Memo

Re: Consultation on an Application

Application reference: PL/26/0868

Proposal: Erection of new Detached Garage

Proposed (plans & elevations) drawing DK/1106/726/B, received 24/9/26

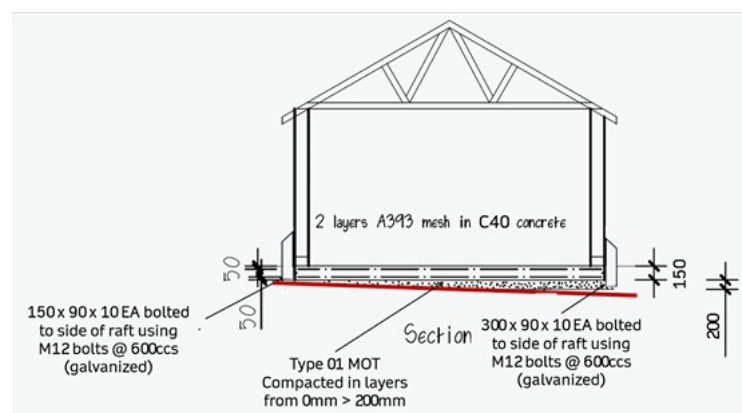
The elevations and garage slab drawing include, respectively:

It is unfortunate that neither labels the existing ground level, as would be expected, particularly given discussions here. For clarity, the existing ground level is taken to be the red line on the elevation drawing above.

It can be seen from the above that the foundations sit on top of the existing ground level and consist of a layer of compacted MOT Type 1 and then a concrete slab, presumably cast on site.

Garage Slab drawing, received 8/9/26

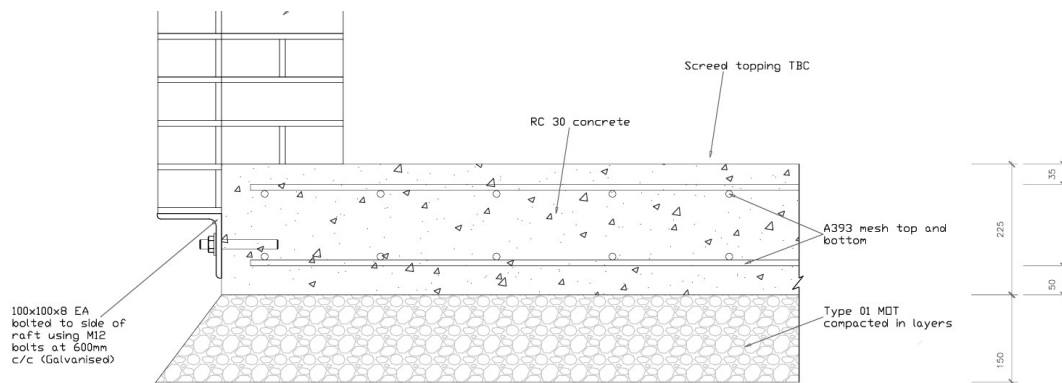
There is no elaboration of the specific foundations proposed or 'appropriate ground covering', which the drawings show to be MOT Type 1 – this is described (elsewhere) as being *'made from crushed rock — usually granite, limestone, or recycled concrete — that ranges from roughly 40mm chunks down to fine dust'*. The inclusion of fines would not normally be acceptable; making it impermeable, but in this case the garage and concrete slab would prevent water reaching the ground anyway. Its use does mean that there is no water penetration or gas exchange anymore within this area of the trees RPA, which is not positive, but I expect will be deemed acceptable due to the less than 20% incursion. I note that it is 'compacted' MOT Type 1, which is what would be expected for this sub-base, however, 7.4 of BS 5837 (cited in the AIR), specifically 7.4.4, states that *'the soil structure beneath the proposed new hard surfacing should be protected from compaction*

during installation' – this would not happen here and the AIR does not discuss this sub-base.

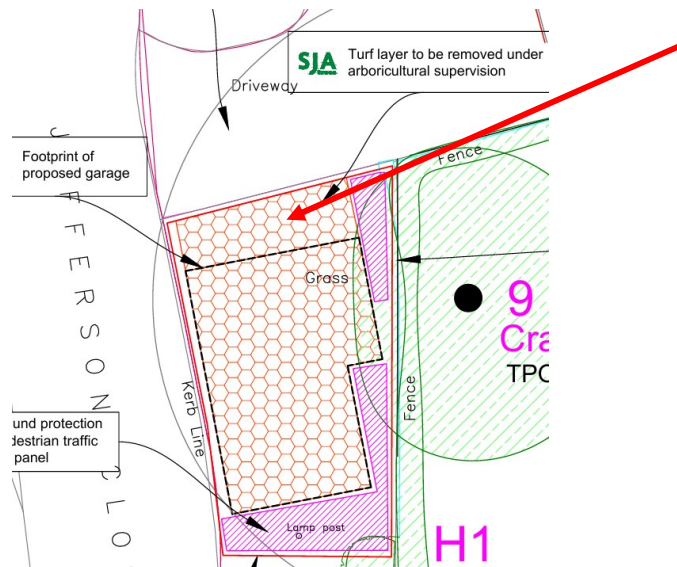
I note from the TPP that there is an area of existing turf to be remove between the existing driveway and garage footprint:

It does not appear that any submissions deal with what is intended here, which I assume will be hard surfacing. It is within the RPA of T9 hence it would be expected to be included in the AIR.

In conclusion, submission have moved forward positively, however some amendments to the AIR are appropriate to discuss the specific foundations proposed and to deal with the area between the garage and existing driveway.
